Access Compliance Report Public Rights-of-Way (Curb Ramps)

Intersection ID: 27575 Main Street: FAWN_HILL_RD **Cross Street: FOX HEDGE RD** Location: SE **ADA ID: E11E377ABA77** Ramp Type: BlendTrans2 Initial Pass/Fail: Pass **Overall Compliance: No Severity Score:**

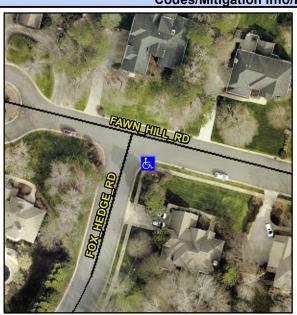
FAWN HILL RD None **FOX HEDGE RD** StopSign Possible Solutions: Remove & Replace Curb Ramp With Two New Directional Ramps or Equivalent. Surveyor Notes: N/A PROW/ADA: Not Found, R305.2

X Walk 1 X Slope (%)	0.7		X Walk 2 X Slope (%)	4.2
N/A	Ramp inside XWalk1?	N/A	N/A	Ramp inside XWalk2?	N/A
	Road Slope (%)	0.9		Clear Space?	Yes
	Road X Slope (%)	3.3	N/A	Clear Space to XWalk (in)	N/A
Yes	Any Obstructions?	No	Yes	Storm Grate/Utility Hazard?	No
	Obstruction Type			Storm Grate/Utility Type	
		N/A			N/A
			Yes	Surface Condition? (G/P)	Good
GIV.			No	Curb Slope (%)	7.4
